# Access Compliance Report Public Rights-of-Way (Curb Ramps)

Main Street: O\_NEILL\_DR Cross Street: BENJAMIN\_DR Location: NW

ADA ID: RPRK211020170451 Ramp Type: Type 1 - Perpendicular Initial Pass/Fail: Pass Overall Compliance: No Severity Score: 25

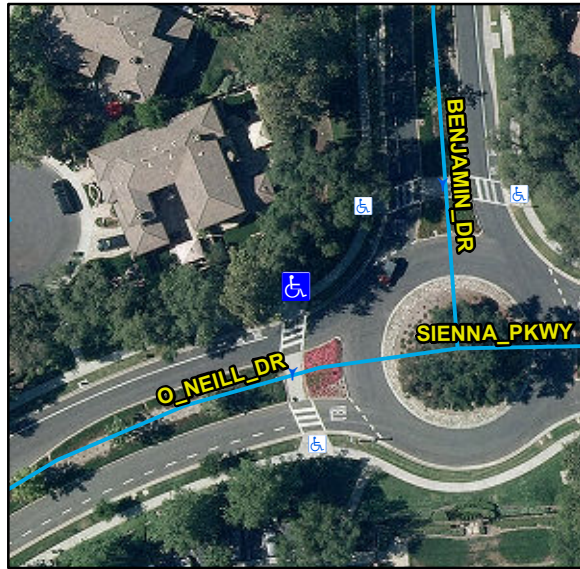
| Compliance | Description                           | Data | Compliance | Description                   | Data   |
|------------|---------------------------------------|------|------------|-------------------------------|--------|
| No         | Landing Width (in)                    | N/A  | Yes        | Flare Slope RT (%)            | 6.4    |
| No         | Landing Run Slope (%)                 | N/A  | N/A        | Flare Traversable RT          | Yes    |
| No         | Landing Cross Slope (%)               | N/A  | No         | DWS Provided                  | No     |
| Yes        | Gutter Ponding                        | No   | No         | Curb Slope                    | 7.5    |
| No         | Gutter Run Slope (%)                  | 9.1  |            | Road Cross Slope (%)          | N/A    |

Remove & Replace Entire Ramp. Remove & Replace Gutter.
